City of Benicia
Community Development Department

Lake Herman Road Solar Project
Initial Study/Mitigated Negative Declaration

May 2020

Figure 3
Landscaping Plan

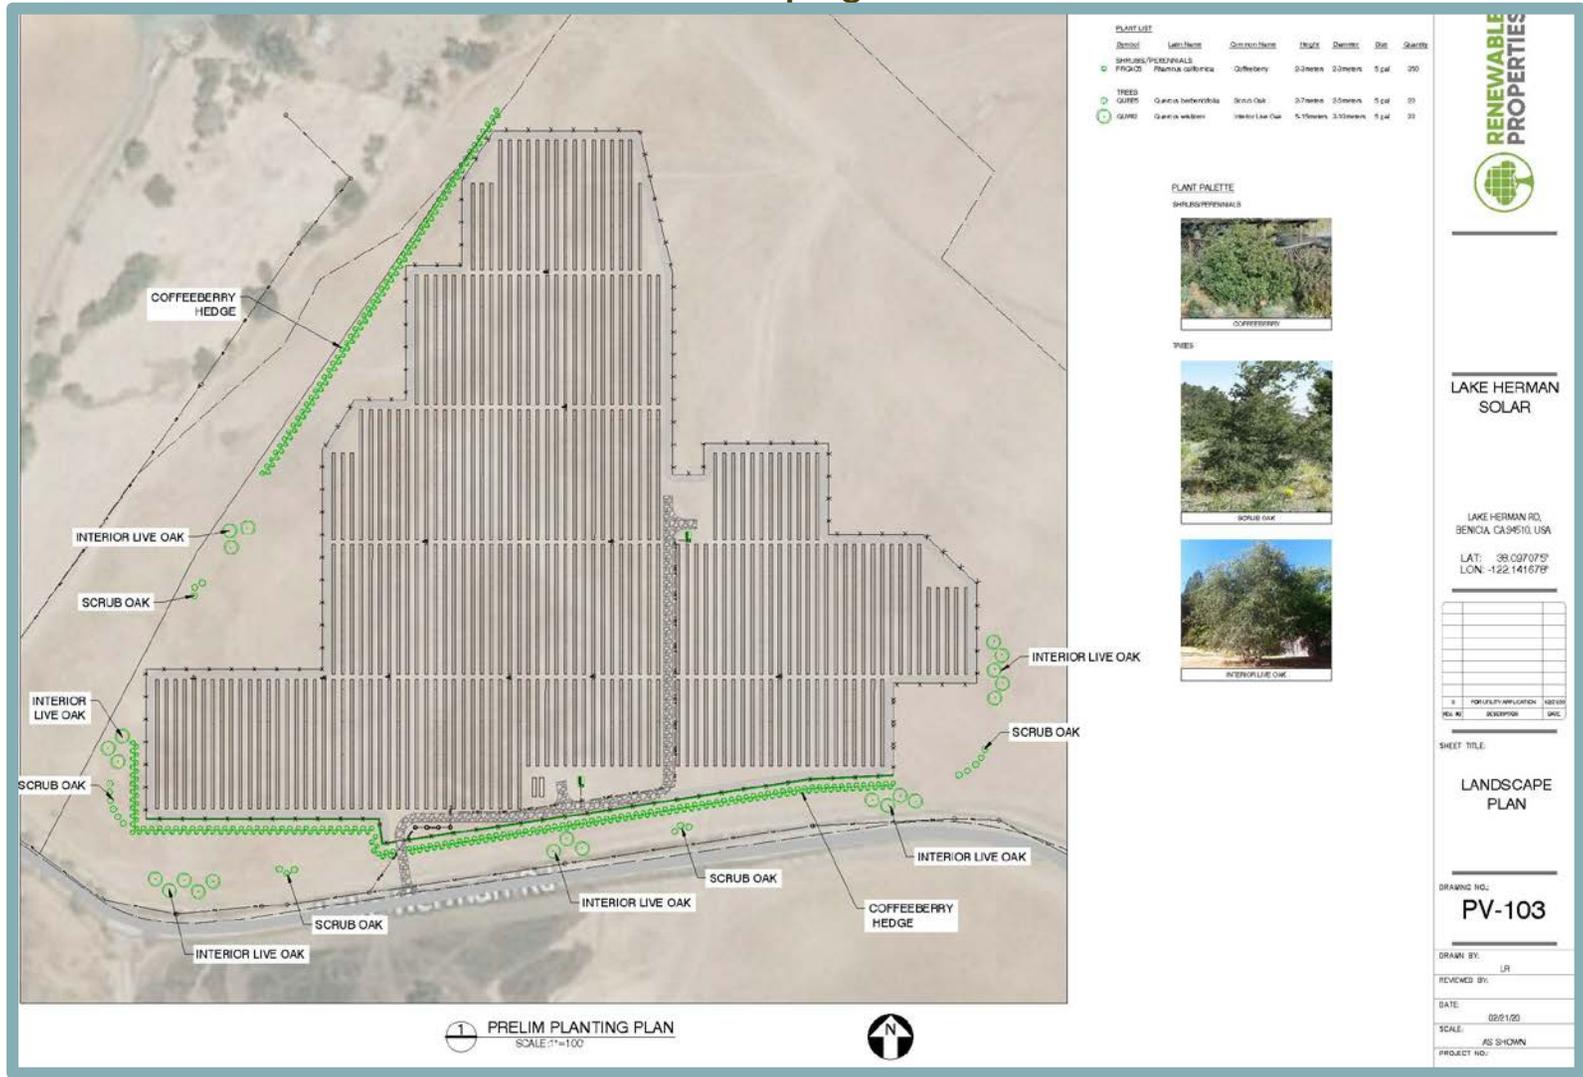
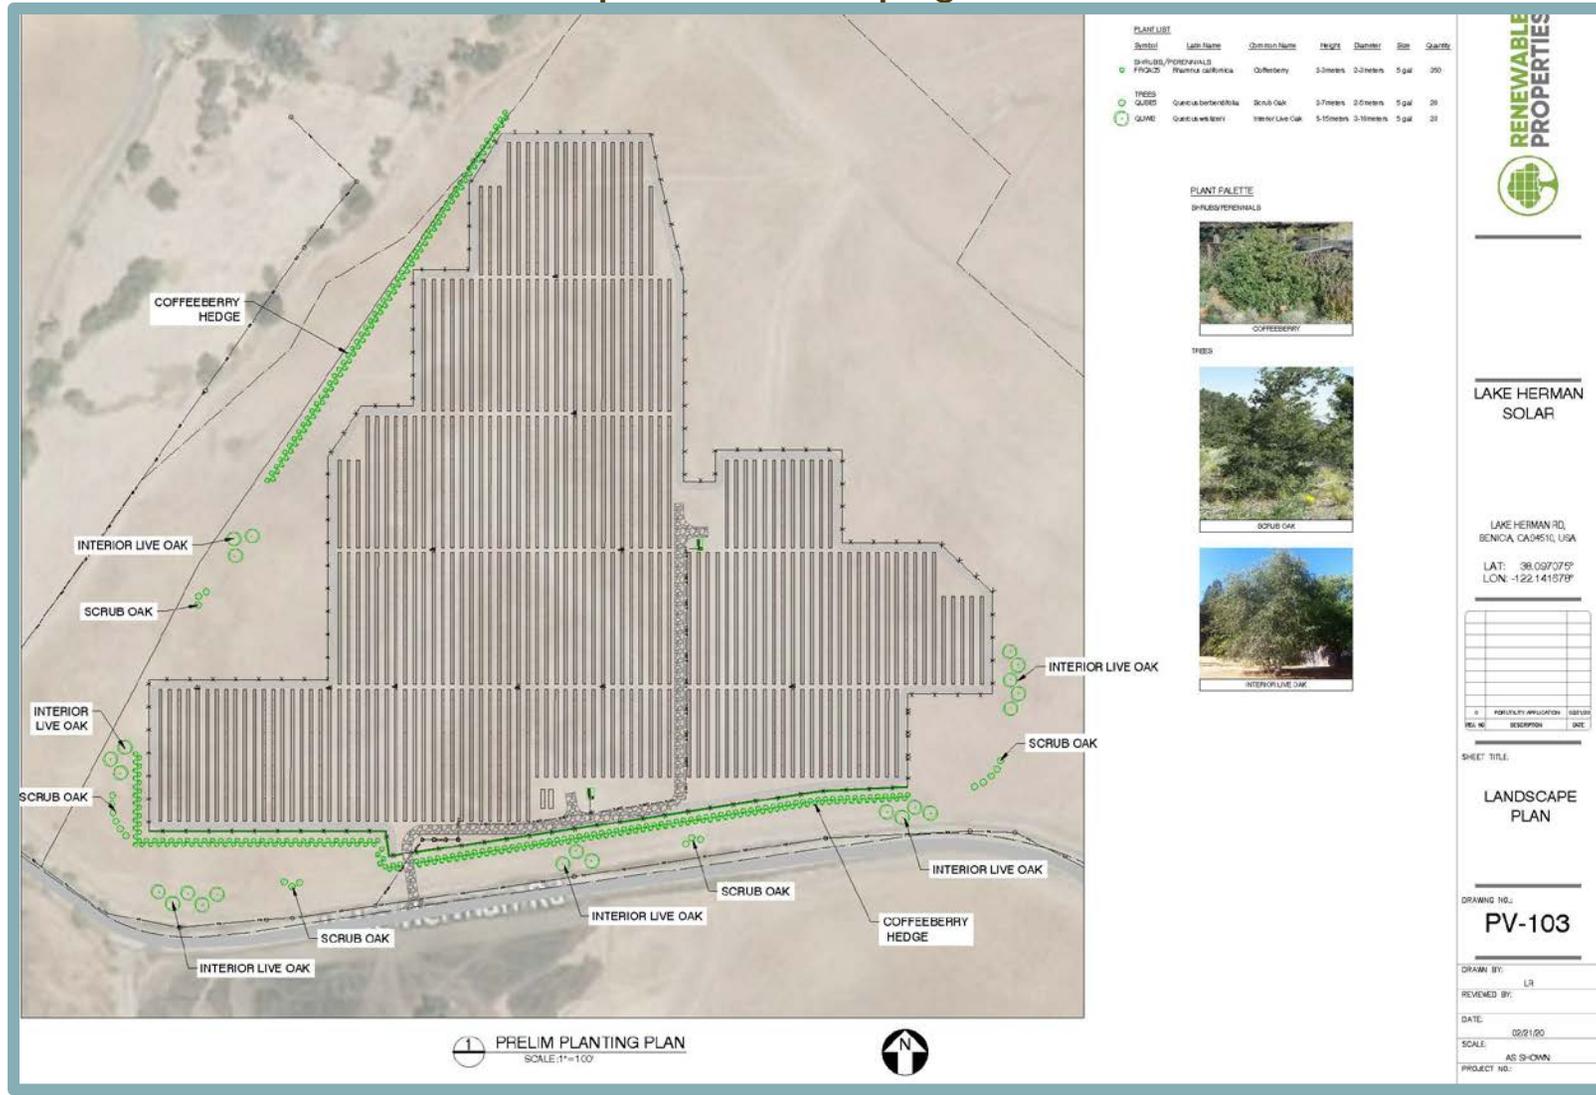
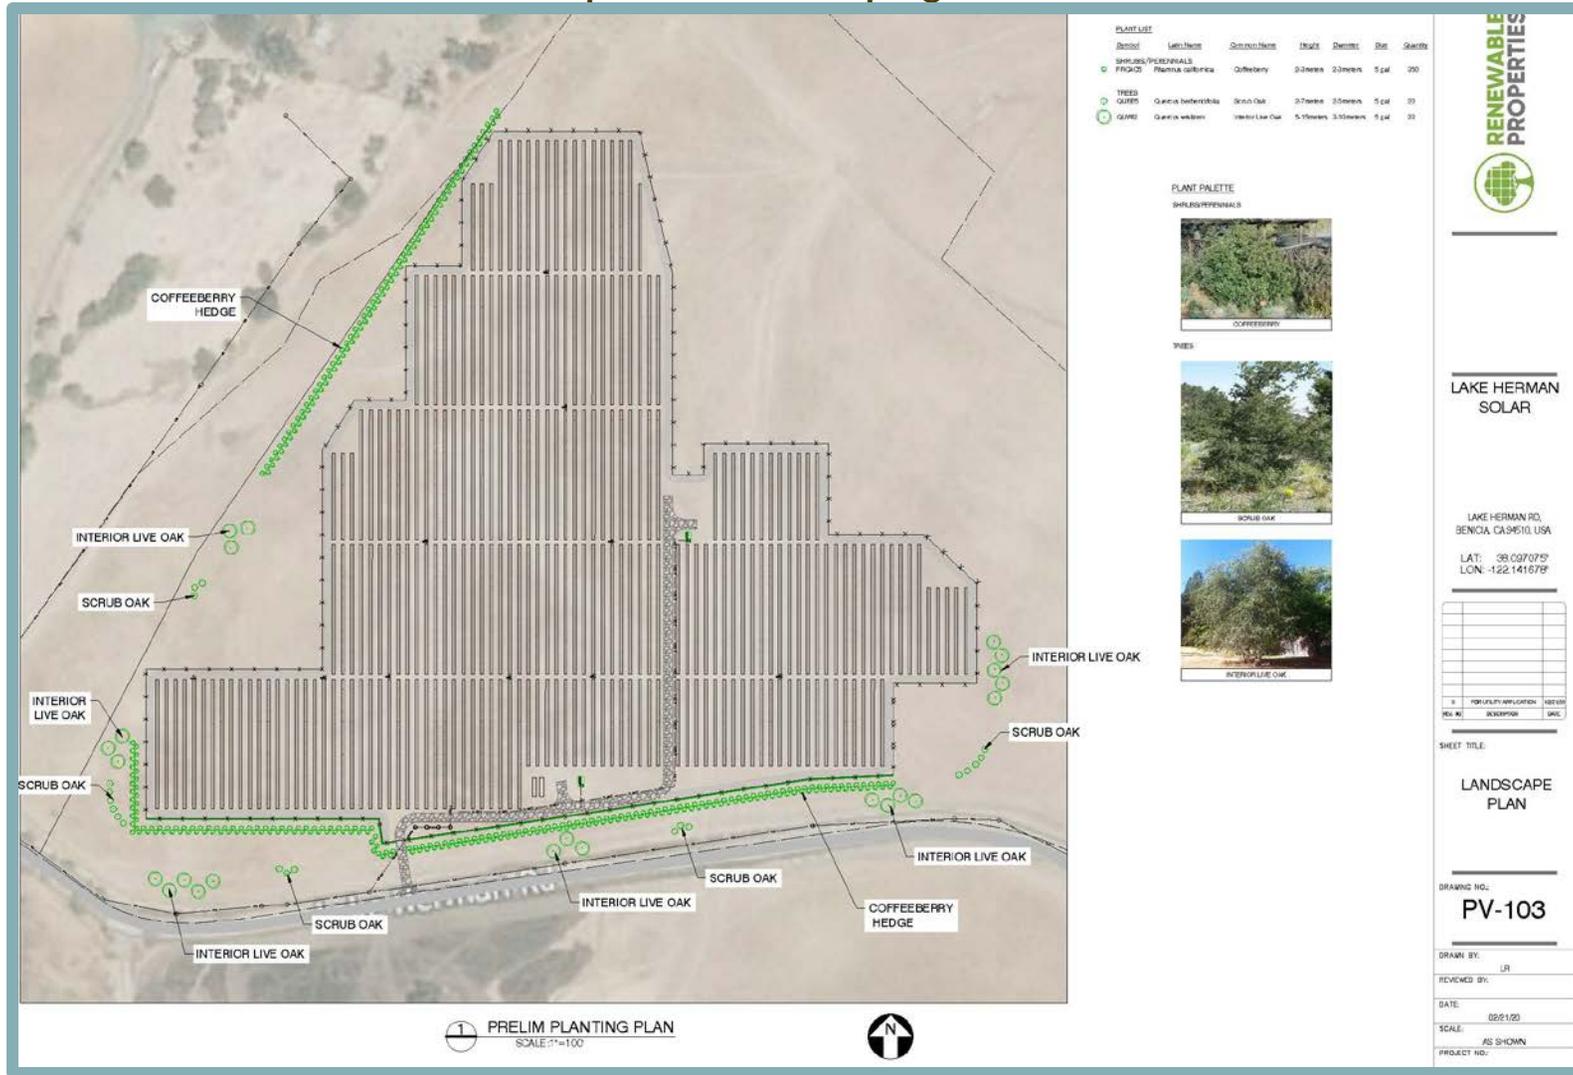
- 1-3 Figures 5 and 6 are at a minimum difficult to understand if not simply misleading. It is not clear to me what Figure 5 is illustrating, but the "road" shown in this Figure 5 does not look like the existing Lake Herman Road that I am familiar with. It is stated that Figure 6 is "demonstrating project size and vegetative screening". It is impossible to correlate what is shown in Figure 6 with what is shown on Figure 3 the landscaping plan. Furthermore, it does not state at what point in time Figure 6 is illustrating, is it in year 1 immediately after project completion or year 10 after the landscaping has had time to mature.

- 2-5** Specifically, the conclusion that Aesthetic impacts are "less than significant" is terribly wrong. The rural image of Lake Herman Road will be irreversibly and negatively impacted 100%. The text explaining Figure 6 is contradicted by Figure 6.

In coordination with City Staff, an updated Landscaping Plan was prepared (see Figure 1), and updated figures were subsequently prepared. The updated figures are intended to replace Figure 6 of the IS/MND, and present the same viewpoint as Figure 6 of the IS/MND, but include the updated vegetation.

Figure 3, Landscaping Plan, on page 10, has been updated and is presented on the following page. The updated Landscaping Plan is provided for clarification purposes, and does not affect the conclusions within the IS/MND.
